TE Connectivity

Product Change Notification: PCN-26-270535

ECP600 series DC contactor

ECP600B series DC contactor bolt apperance change

Flatness on the top side of the bolt

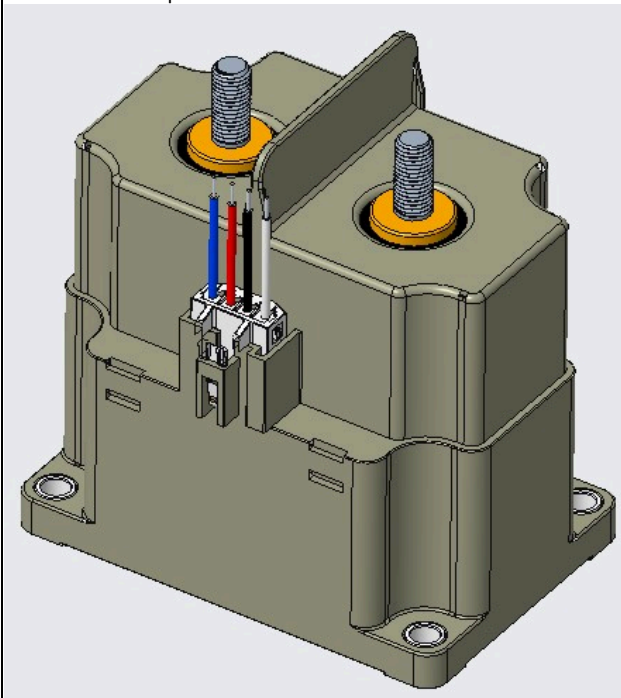
Please be aware of an upcoming feature change to the listed part numbers. Before: The top side of the M8 bolt is flatness on the main contact terminal. After: Add a flat-head screwdriver on the top side of the M8 bolt on the main contact terminal.
